Oakley Greenwood

Responses to issues raised on CBA

prepared for:
Electricity Authority

Project	Responses to issues raised on CBA
Client	Electricity Authority
Status	Final
Report prepared by	Rohan Harris Greg Thorpe
Date	2 December, 2016

Figure 1: Shape of supply curve for alternative to a transmission investment at every transmission node that would be required for the RCPD signal to not be distortionary

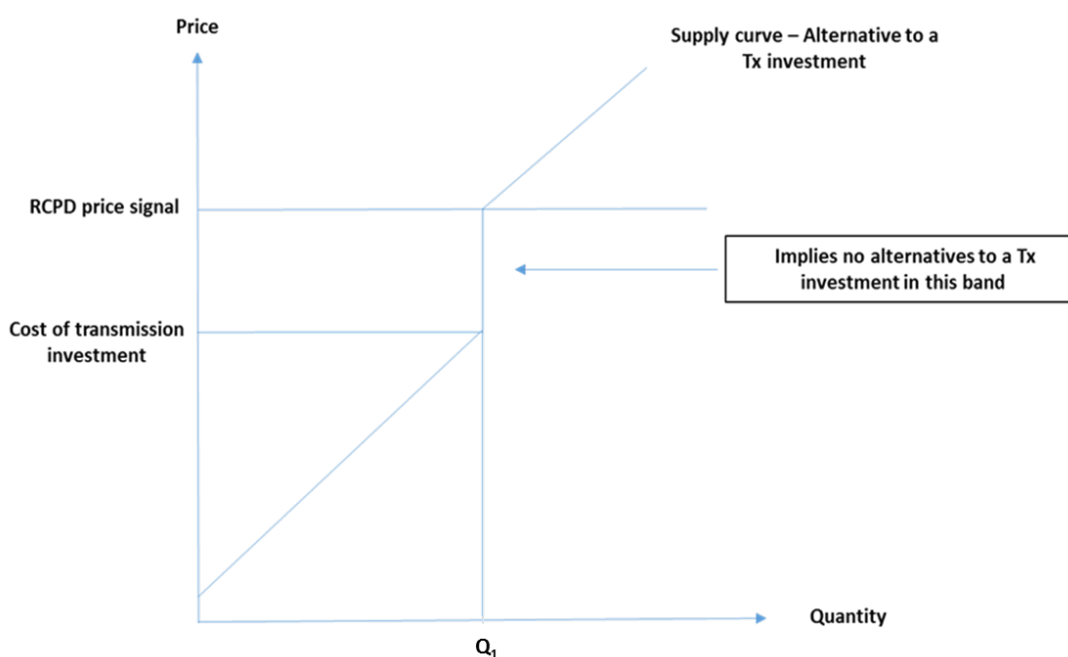
- That the RCPD charge reflects, and will continue to reflect, a robust estimate of the forward-looking costs of providing transmission services (e.g. Transpower's marginal cost) at each transmission node. This is despite the fact that the RCPD charge is not in fact designed to signal the costs of Transpower's future transmission costs, rather, the RCPD charge is predominately a means by which Transpower recovers the costs of its historical investments¹³. Even absent any analysis, this is unlikely to hold true. Further the RCPD price signal is the same across NZ, yet the forward-looking cost of providing transmission services will almost certainly be different in different areas. We note that Transpower states that the "*RCPD charge is not well correlated to LPMC*"¹⁴, or

- Even if the RCPD charge does not meet the first test (above), it does not drive inefficient future consumption or investment behaviour. For this to hold true, one would need to establish that every single possible investment (whether DG or DR or anything else) that is promoted by the RCPD charge is cheaper than the alternate transmission investment. For this to hold true, the supply curve for alternatives to a transmission investment must be vertical over the price range that covers the difference between the cost of the alternative transmission investment, and the RCPD price signal. This is illustrated in the figure below.

Figure 2: Potential impact of a wealth transfer, if there is no response from a distribution business

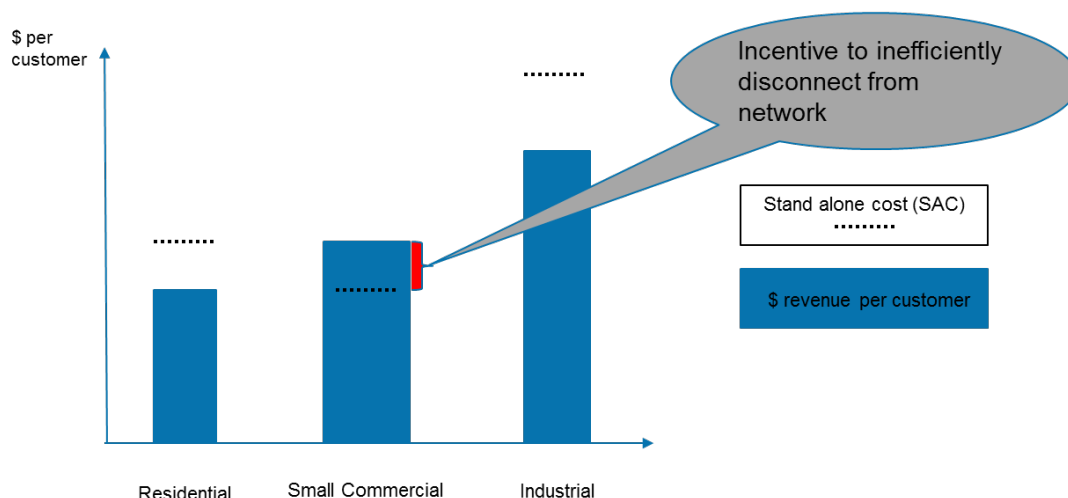
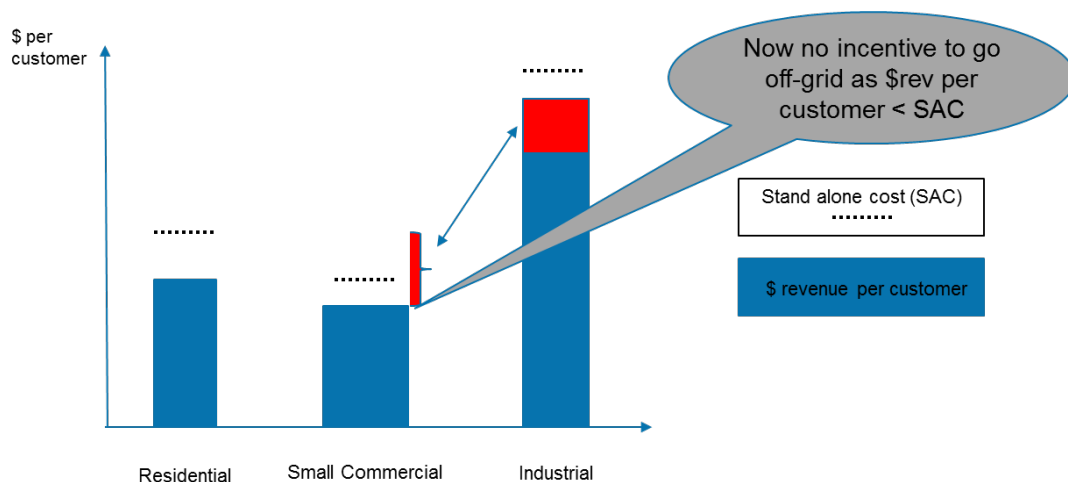
- **It is not plausible to suggest that around \$850m (in NPV terms over twenty years) in additional transmission charges could be allocated to load customers without there being at least some reduction in demand:** Firstly, based on reading the source document, it is not clear how this figure has been derived. Notwithstanding that, if we take the \$850 million on face value, to our mind, this would not seem to us to be a particularly large proportion of retail electricity bills over a 20-year period. Moreover, and most importantly, the comment appears to conflate the impacts of the wealth transfer (“\$850m...in additional transmission charges could be allocated to load customers”) with the impact that is created by adopting inefficient retail pricing structures to recover those increased costs. Put another way:

In short, changes to the transmission pricing arrangements need not lead to inefficient disconnections from a distribution network, wherever a distribution network can rebalance its tariffs to remain within the standalone cost threshold. Given the relatively small contribution transmission prices make to final retail bills (and the wealth transfer stemming from the proposed changes), and the large gap between most customers' standalone cost and their retail bills (predominately reflecting the natural monopoly characteristics of electricity network businesses), this risk is not considered material.
